From: Julie Haerland
Sent: 26/06/2024 1:37:17 PM
To: Council Northernbeaches Mailbox
Cc: Bob Vinks; Stef Vinks
Subject: TRIMMED: Objection- 25 Valley Road, Balgowlah Heights DA2024/0633
Attachments: 11am June 21.pdf; 12noon June 21.pdf; 10am June 21.pdf; 9am June 21.pdf; Objection Letter- 25 Valley Road Balgowlah Heights.pdf; SERVICE PROTECTION REPORT.pdf;

Re- DA 2024/0633- 25 Valley Road, Balgowlah Heights

SERVICE PROTECTION REPORT
18 CONDAMINE STREET
BALGOWLAH 2093

If you wish to discuss this further I can be contacted on [REDACTED].

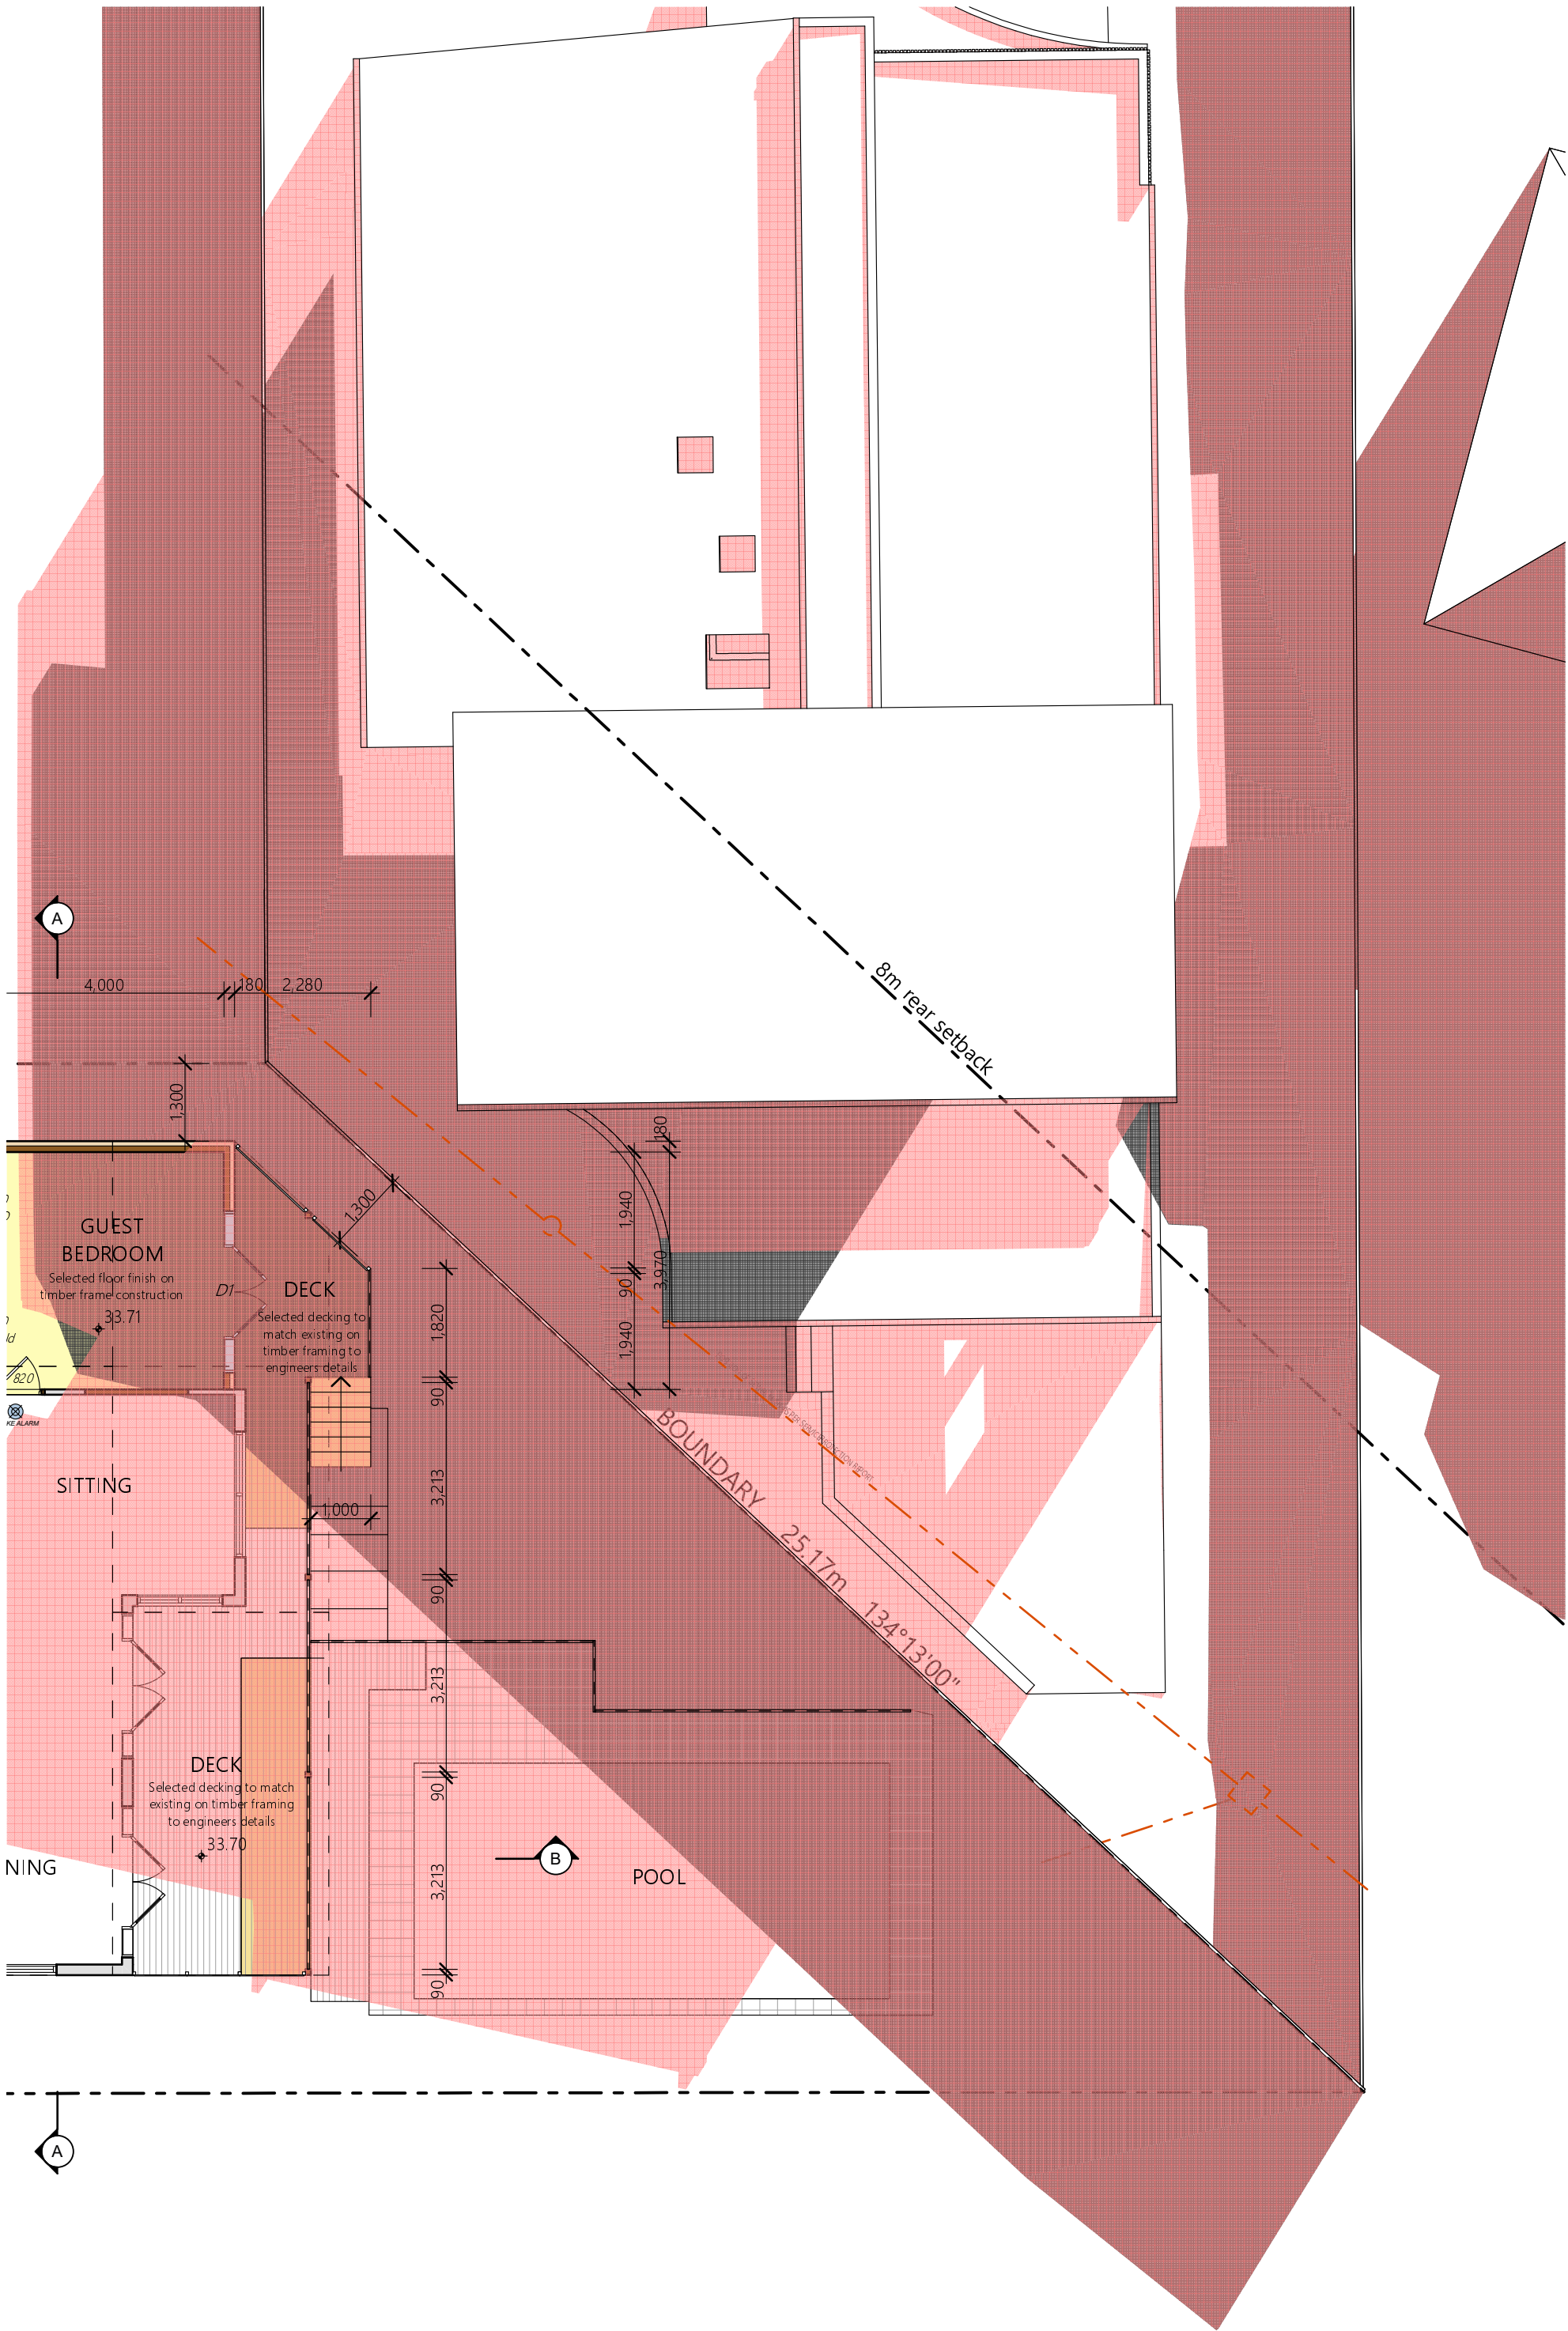
The proposed additions at 25 Valley Road come right up to the rear boundary and will completely overlook the private open space and swimming pool of 18 Condamine Street. The structure will create an extensive amount of additional overshadowing. We have provided shadow diagrams that now show the relationship of 18 Condamine Street to the proposed alterations at 25 Valley Road. As you can see the rear yard, deck and pool will almost be completely shaded from 9am right through to 12 noon. This will drastically reduce the amount of lovely northern light on the entire area of principal open space of 18 Condamine Street. The DCP states: *“New development (including alterations and additions) must not eliminate more than one third of the existing sunlight accessing the private open space of adjacent properties from 9am to 3pm at the winter solstice (21 June)”*. The proposal clearly takes away half of the existing sunlight and as such does not comply with aims and objectives of the DCP.

Furthermore, it is noted that as part of the recent Council approval on 18 Condamine Street, the Boards sewer was pegged out (see attached). This pipe is shown on the shadow diagrams attached to this objection letter. The proposed alterations and additions at 25 Valley Road will impede this pipe. In fact, we would suggest that Sydney Water approval would not be given for the structures proposed.

- Greatly increased rear boundary setbacks to provide additional privacy and reduced overshadowing of 18 Condamine Street
- Privacy measures to the rear alfresco- moving it further to the east and north.
- Strict adherence to the 55% soft landscaping
- Any hedging proposed along the rear boundary to reach a maturity of 2m maximum from ground level of 25 Valley Road
